ADDENDUM NO. 6

PROJECT: A1/A2 Reservoirs and B/C Booster Pump Station Project

CIP NO.: GW-0112

ISSUED: February 12, 2021

SHEET
C-104
OF

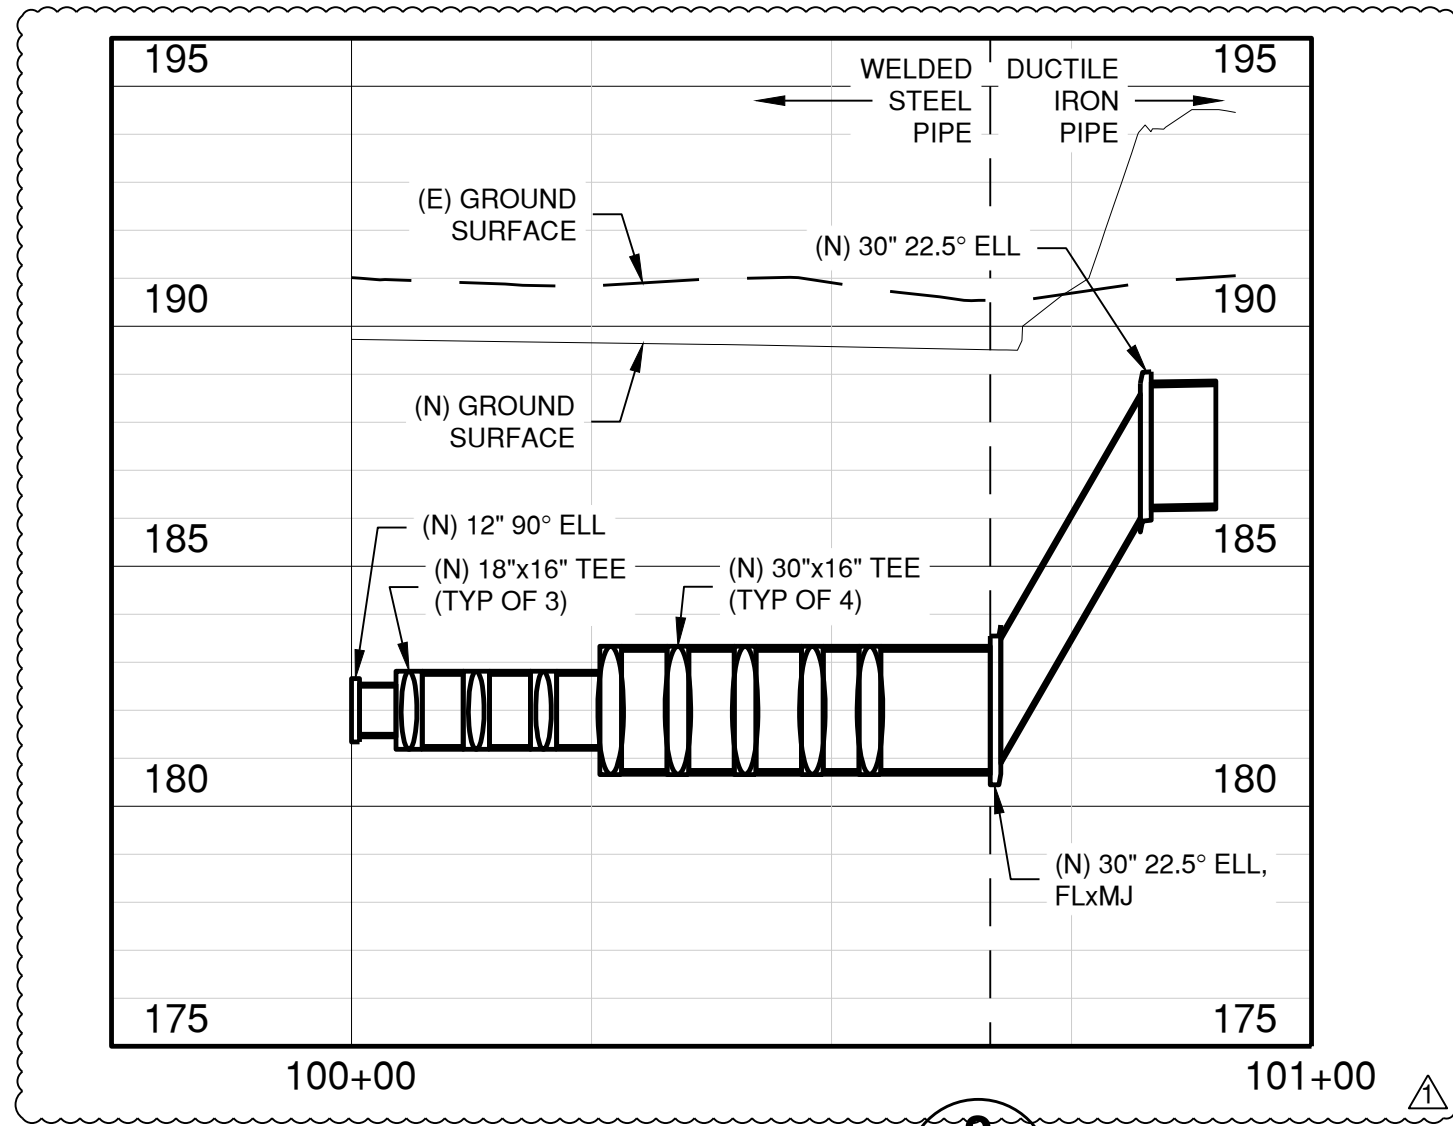
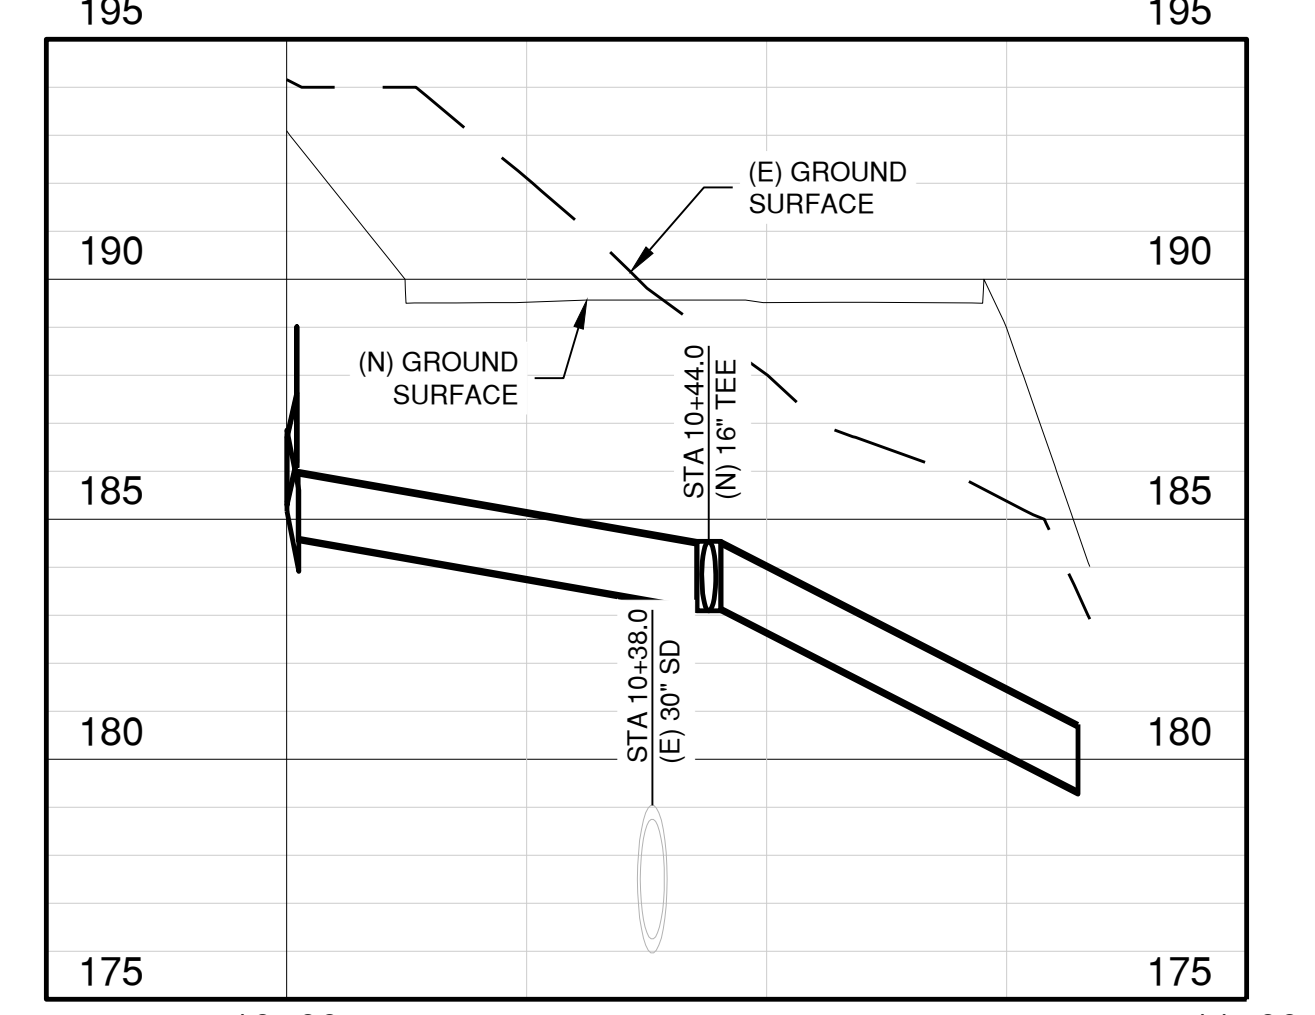
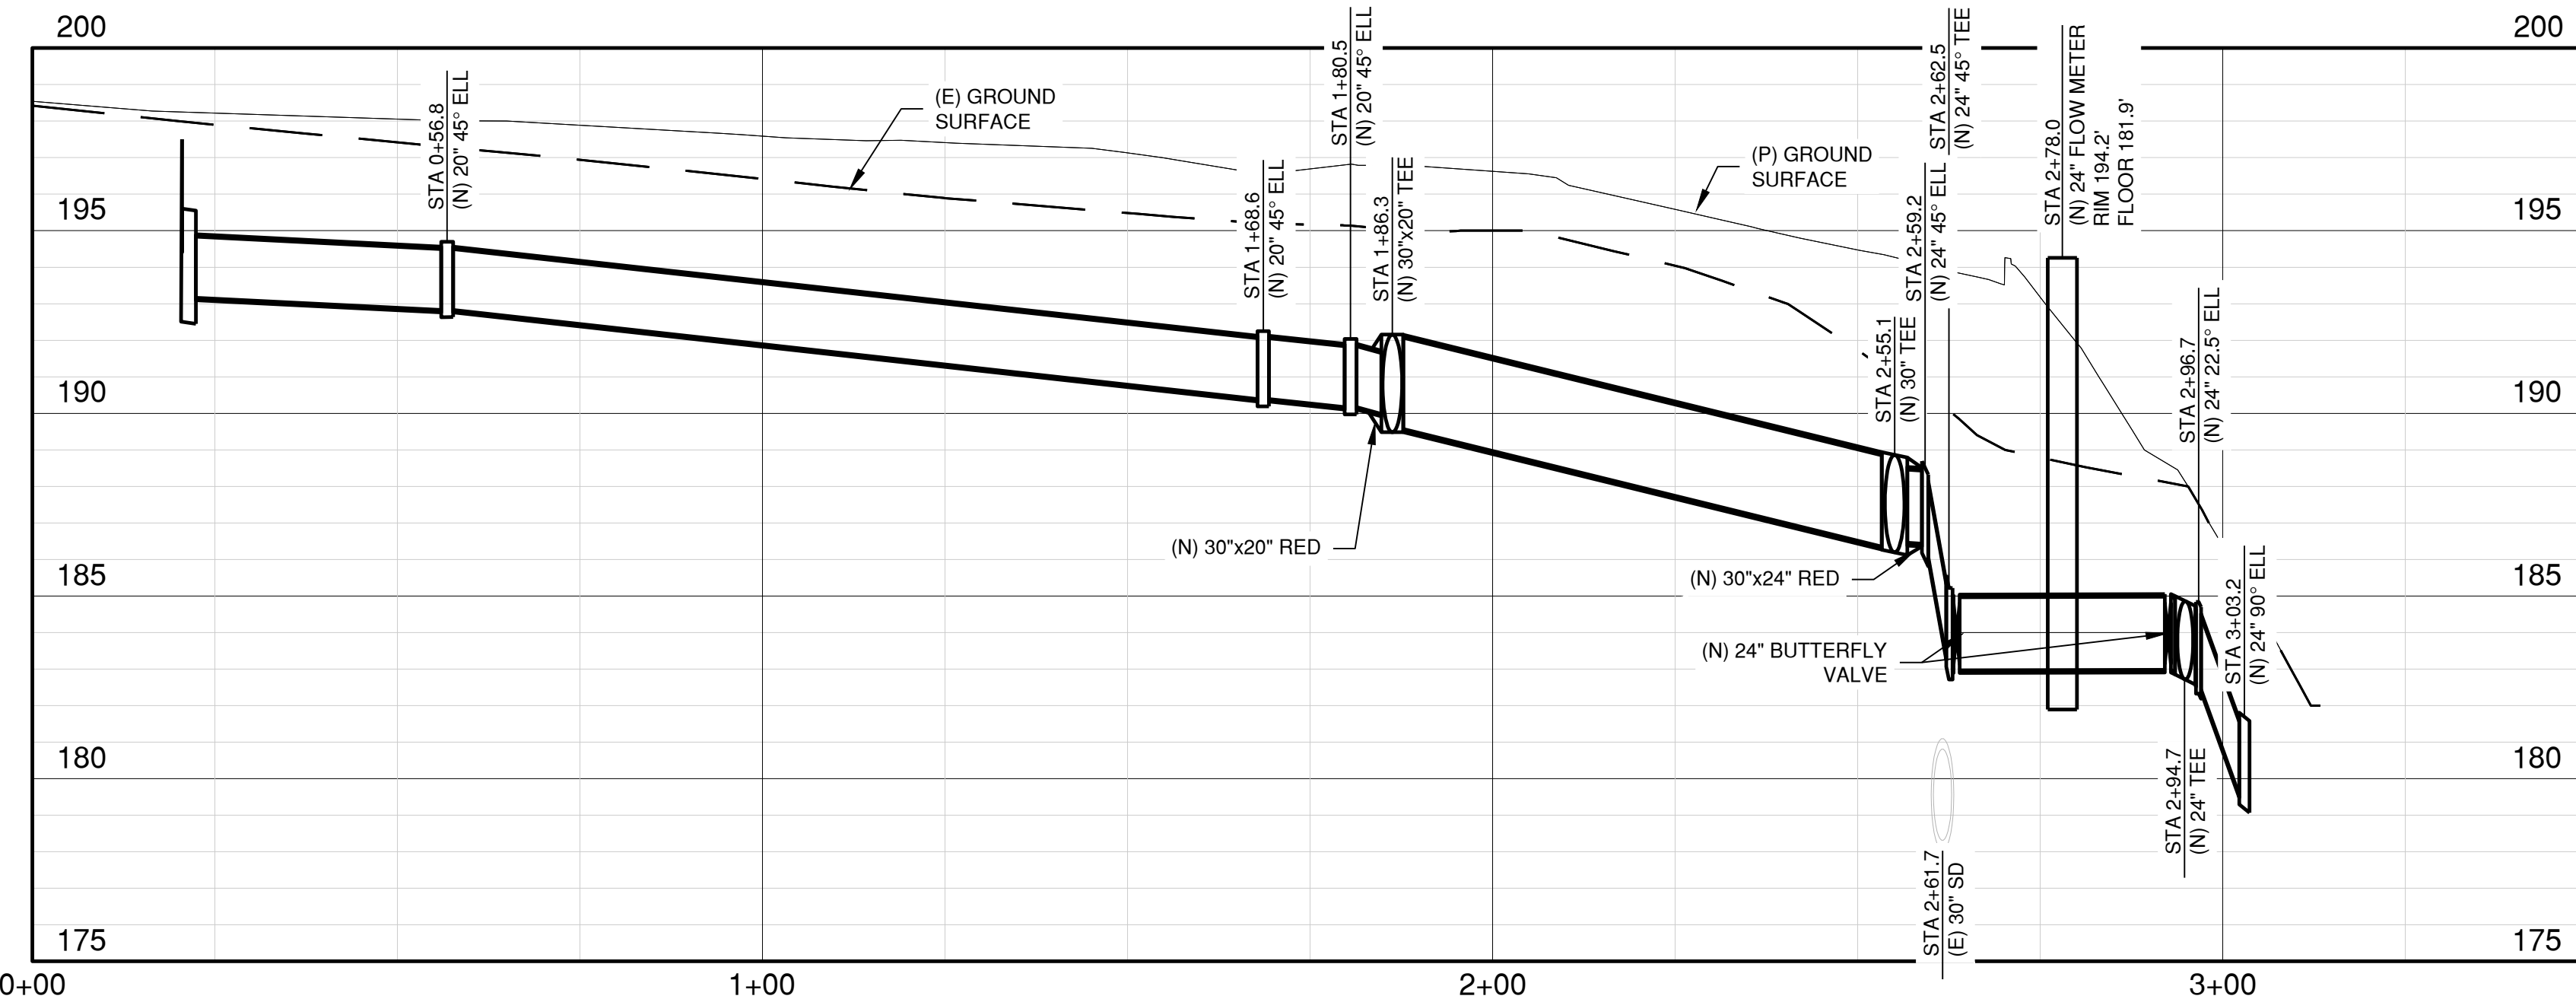
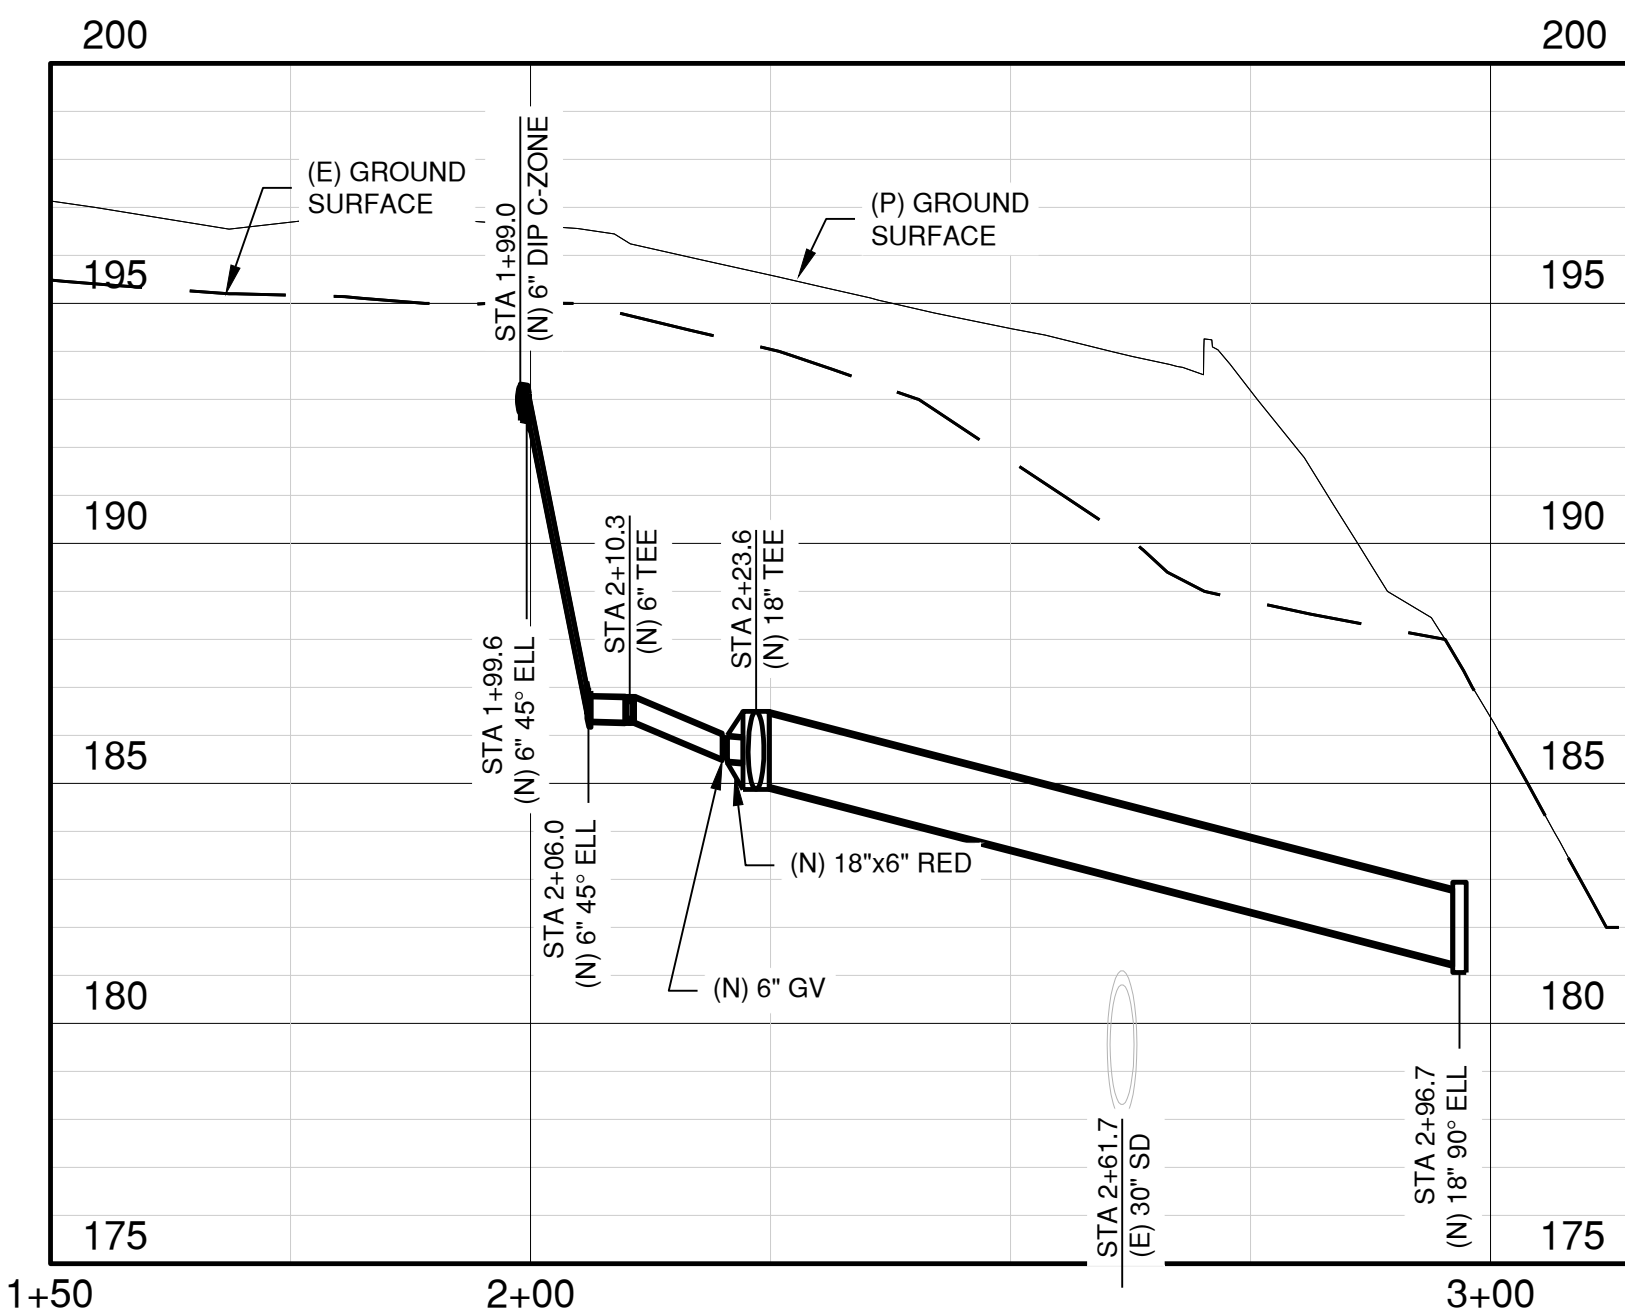
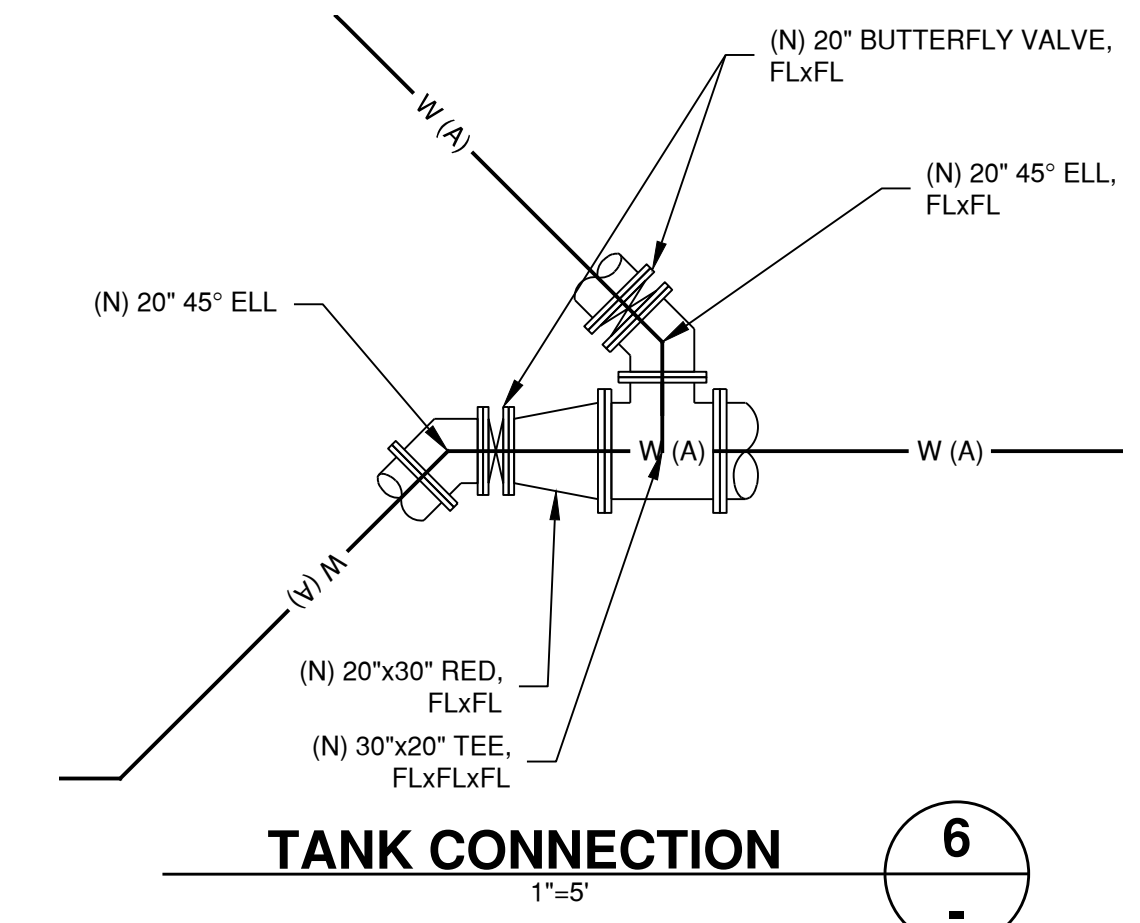
- A. Sheet C-012, Detail 4. The callout "INSTALL TWO SOCKET CLAMPS..." is revised to read "INSTALL TWO MJ RESTRAINT COLLARS..."
- B. Sheet C-015, Detail 2. Add the following note:
NOTE: CONTRACTOR MAY PROVIDE A 24" WYE OR A 24" TEE AND 45° BEND.
- C. Sheet C-104 is reissued to define the transition point between ductile iron pipe and cement mortar lined and coated steel pipe, and to show the valves on the pump station intake pipes as they are shown on C-120 (attached).

Q9 What material is the 30” Manifold to be constructed out of shown on C-120 and C-104?

A9 The 30-inch manifold and pump station laterals are to be cement mortar lined and coated steel pipe per Section 33 11 13.20. Sheet C-104 is reissued with a clarification showing the transition point from ductile iron to steel pipe.
